WESTERN NUCLEAR, INC.

February 16, 2004

**SUBJECT: Response to November 18, 2003, Nuclear Regulatory Commission
Staff Letter Regarding Western Nuclear, Inc.'s Split Rock Uranium
Mill Site Final Site Closure Proposal, SUA-56**

FIGURE 1
EXISTING AND PROPOSED
MONITORING WELLS

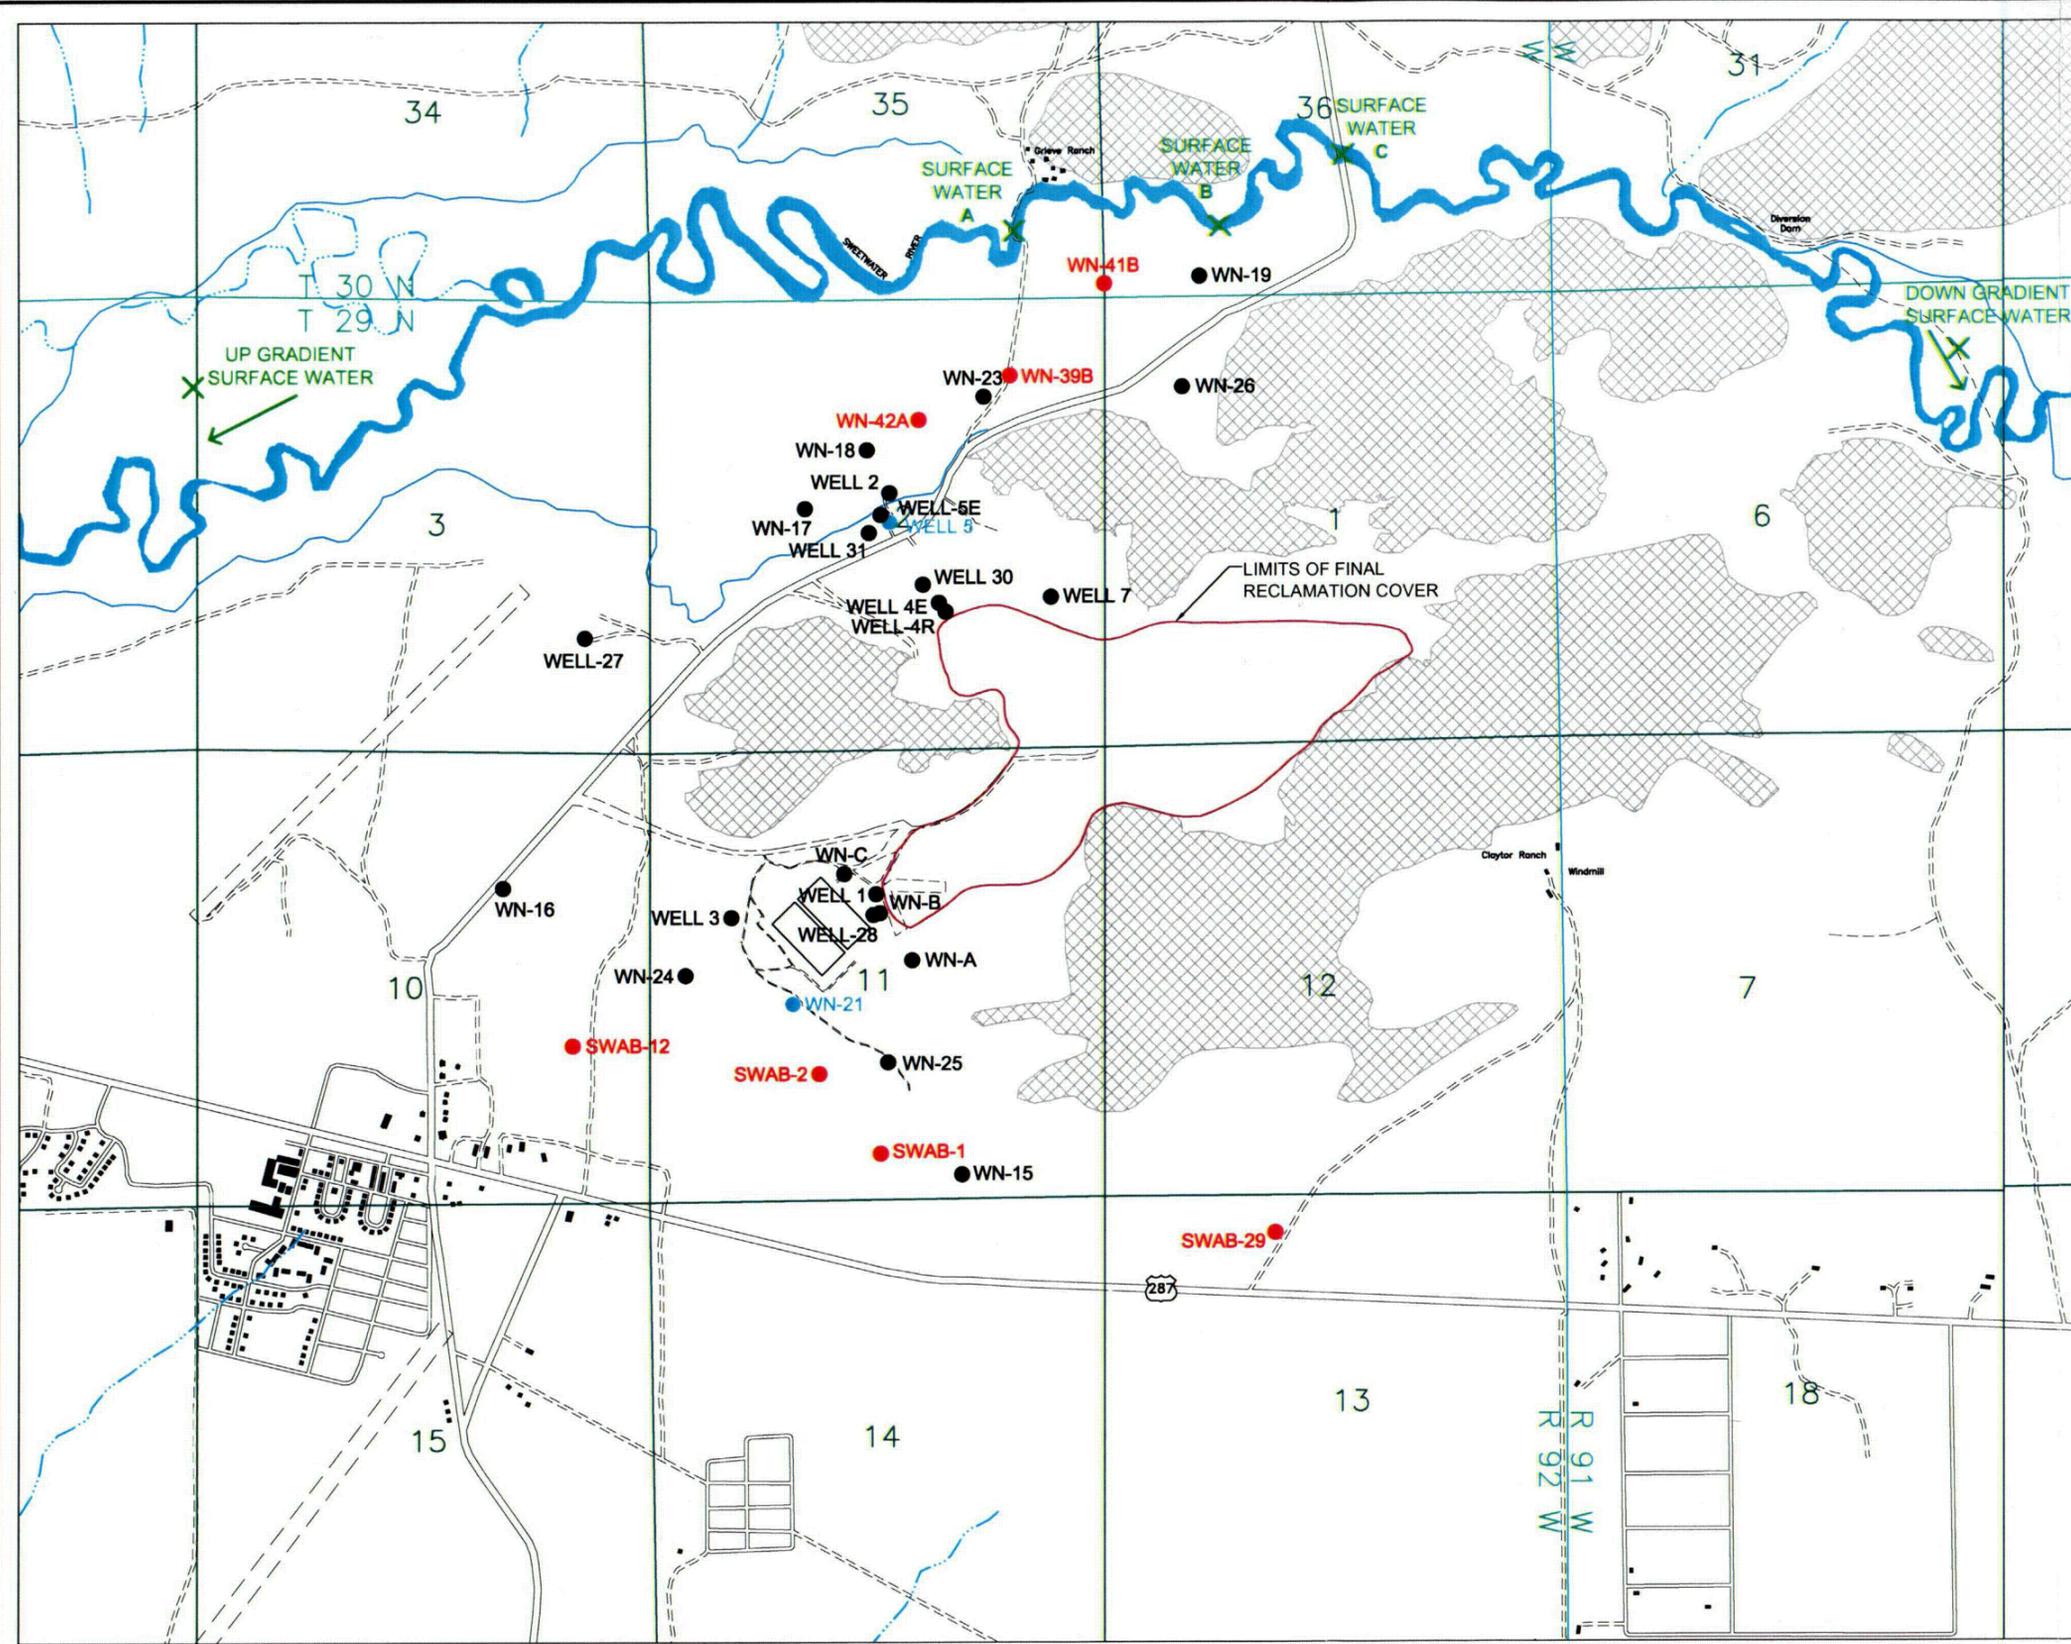
4. *In NRC's RAI, dated September 6, 2001, item number 2 requested that WNI address the deficiency of a long-term groundwater and surface water monitoring program. WNI's response of May 28, 2002, on this item is not adequate. William von Till discussed this issue in detail with Lou Miller in a phone conversation on November 4, 2003. This is also covered in the NRC Guidance document NUREG-1620, Section 4.3.3.4.*

A new groundwater and surface water monitoring program is proposed. This system is designed to better monitor evolution of the groundwater plume and to provide more detail for the surface water monitoring program. The location of the existing monitoring locations and the new proposed locations are shown on Figure 1.

Point of compliance (POC) wells, proposed in the October 1999 groundwater report (SMI, 1999), are Well 5 and Well WN-21. The proposal for these wells to be the POC wells remains the same.

Two new points have been added to the surface water sampling system. These points are labeled Surface water B and C. They supplement the existing sample location A to better monitor water in the Sweetwater River that might be impacted from the contaminate plume.
